Defining the training patterns

NVIDIA

Comments 414 and 415

Statistics of the PRBSQ alone, without the training header

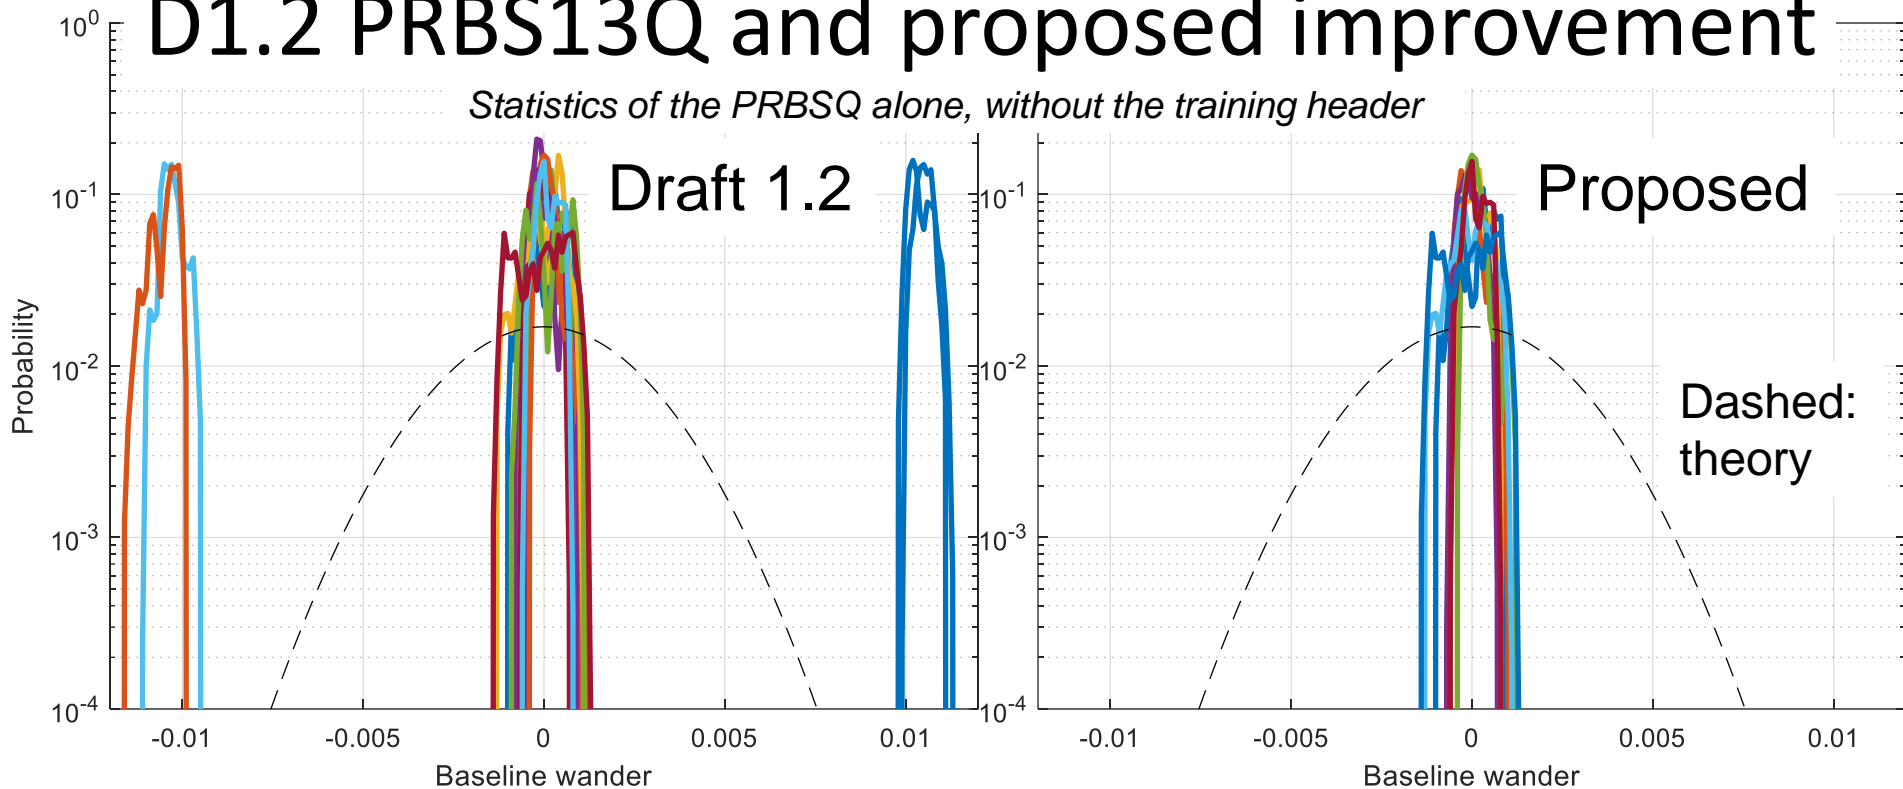
- Baseline wander statistics of the possible PRBS13Q, 4 polynomials, both precoded and not, any seed
- Four unbalanced patterns should be avoided
 - The standard should warn against creating these
- The two on the left are precoded, i is 1 or 5, with the default seed
 - The two on the right are precoded, "Default identifier" (polynomial ID) 3, and a non-default seed
- Some patterns are 8191 UI long, some precoded patterns are 16382 UI long

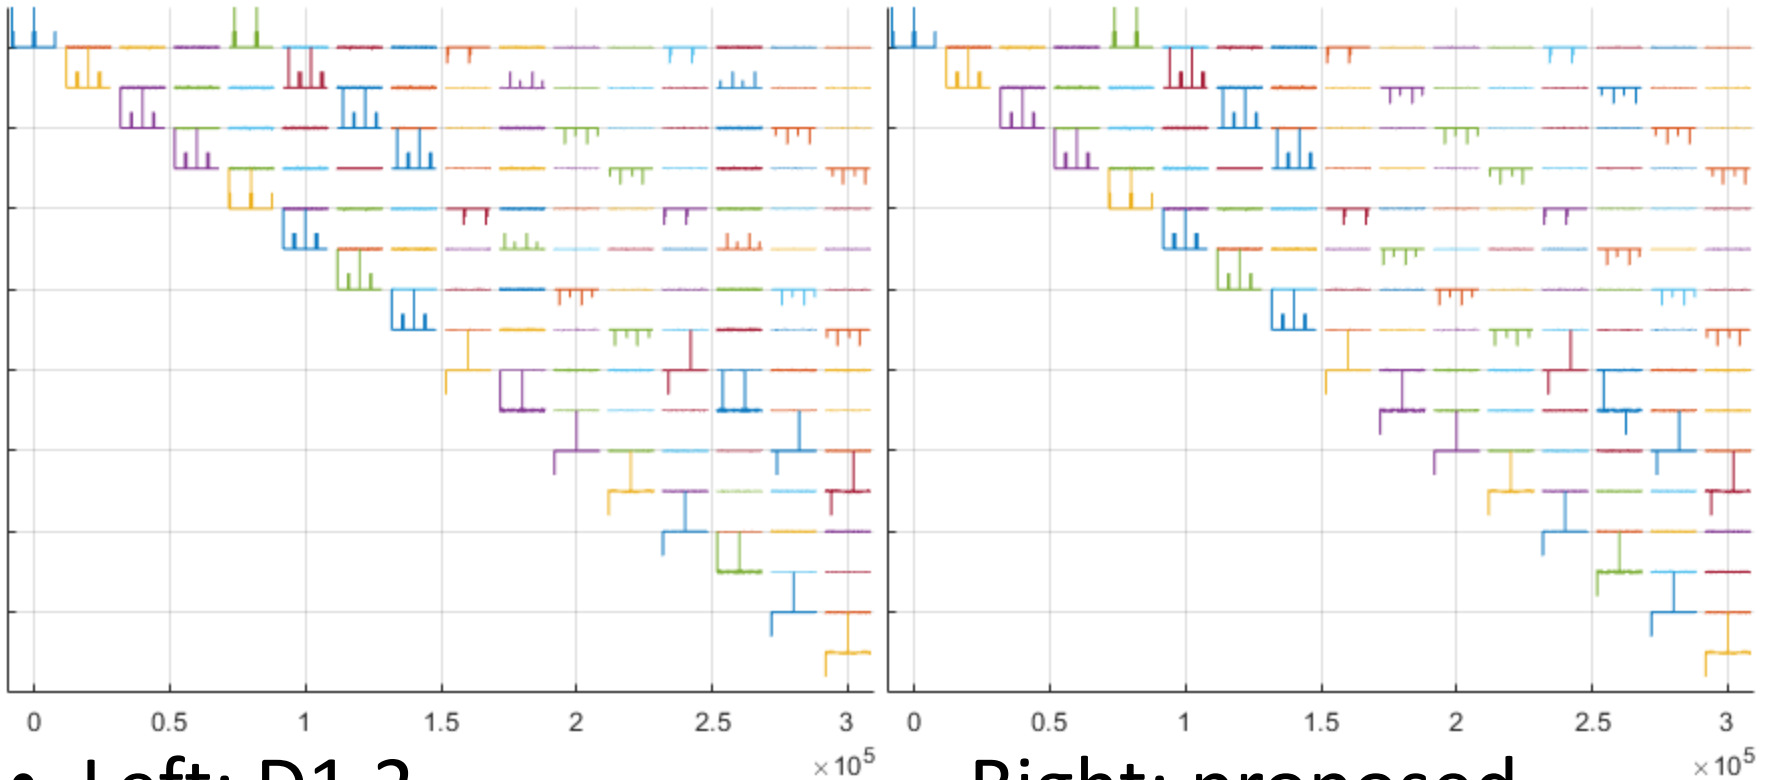
- Baseline wander statistics of the proposed set of PRBS13Q, 4 polynomials (8 i), both precoded and not, revised default seeds
- The unbalanced patterns are avoided
 - for the proposed default seeds
- The 4 non-precoded patterns are 8191 UI long, the 4 precoded patterns are all 16382 UI long
 - Nice minor benefit

To avoid ambiguity, it may be desirable to add another UI to the "Initial output, PAM4 with precoding" column

<i>i</i>	Default identifier (ID of polynomial)	Default seed_ <i>i</i>		Comments
		D1.2	Proposed	
0	0	0000010101011	0000010101011	
1	1	0011101000001	0111010000011	Rotated 1 bit
2	2	1001000101100	1001000101100	
3	3	0100010000010	0100010000010	
4	0	1111110100110	1111110100110	
5	1	1100011101110	1000111011100	Rotated 1 bit
6	2	0000001101000	0000001101000	
7	3	0011000100111	0011000100111

Candidate PRBS31Q

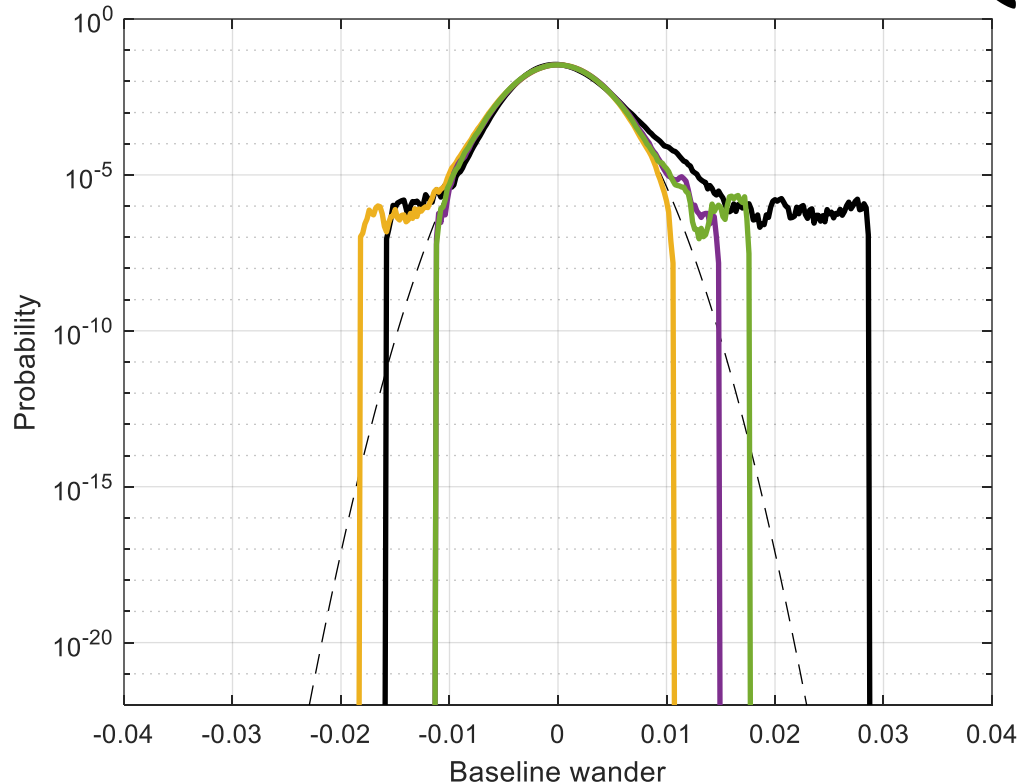
- Black: Not precoded. More challenging than real traffic, best for conservative testing
- Yellow, green and purple: precoded
- Purple is the most representative for baseline wander – best for training
- Also its transition density statistics are somewhat better than un-precoded PRBS31Q
- This is the recommended choice. As it happens, it is also the default, if the PRBS31 is initialised as in 120.5.11.2.2 (seed is all 1s). So define it like this
 - As already stated in the draft, different initializations should be used for different lanes
